Envar Cambridge Section 5 Response

RESPONSE TO SCHEDULE 5 DATED 21 JANUARY 2026
(EPR/GP3930DF/V006)
13/03/2026

The Environment Agency has sent a Schedule 5 Request for further information to Envar Composting limited (the operator) to clarify some matters relating to an environmental permit application to vary the existing bespoke permit EPR/GP3930DF, submitted in September 2024 and Duly Made in April of 2025. The Envar Composting Facility, The Heath, Woodhurst, Huntingdon, Cambridgeshire PE28 3BS, hereafter referred to as 'the Site'.

Figure 1 Current air handling system

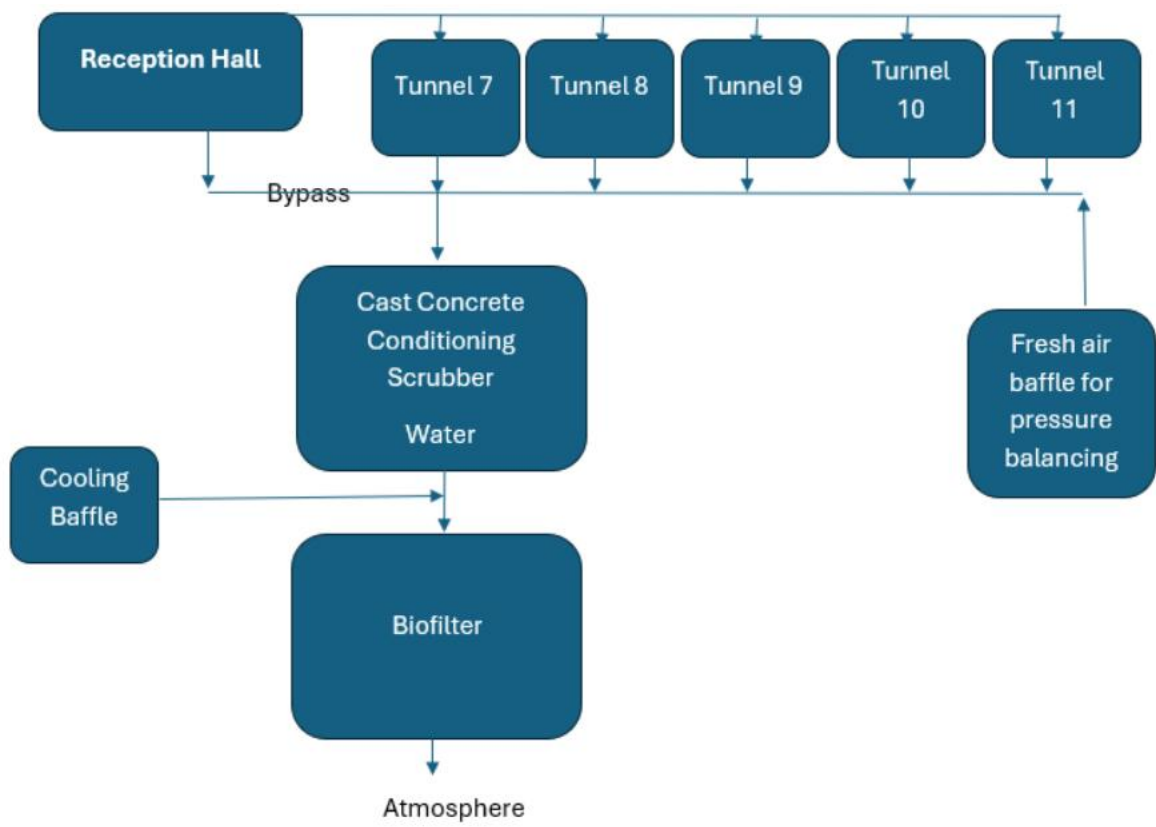
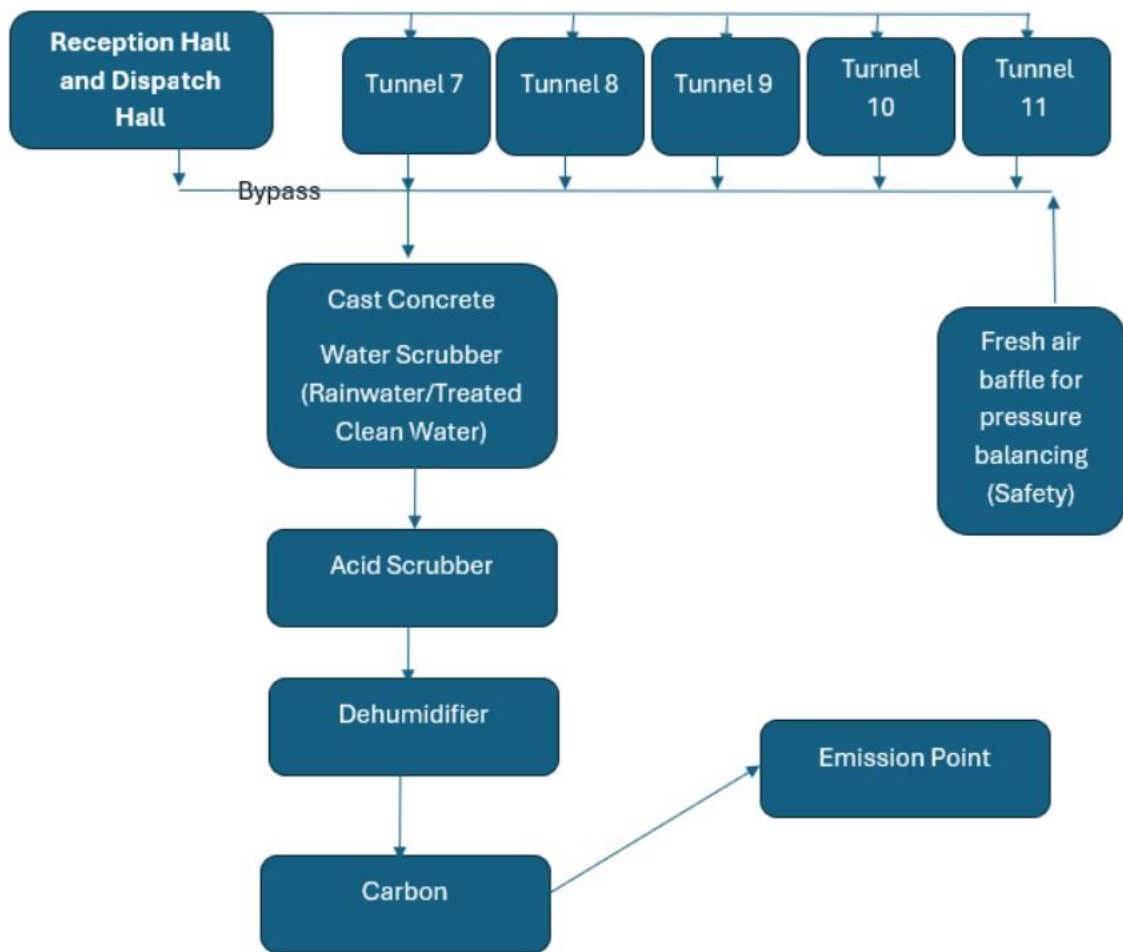
Note² - The Odour management plan v.8 Table 3(a) Ref. C Feedstock preparation details 'Fully enclosed with extraction ventilation'. Provide clarification on whether the ventilation is channelled to the abatement plant.

Yes – all emissions are channelled to the abatement plant from the processing tunnels and from the building itself. We have provided process flow schematics of the current air handling system (Figure 1) and Proposed air handling system (Figure 2). Further detail is provided within the supporting document Envar Cambridge Abatement Improvement Plan v1.0.
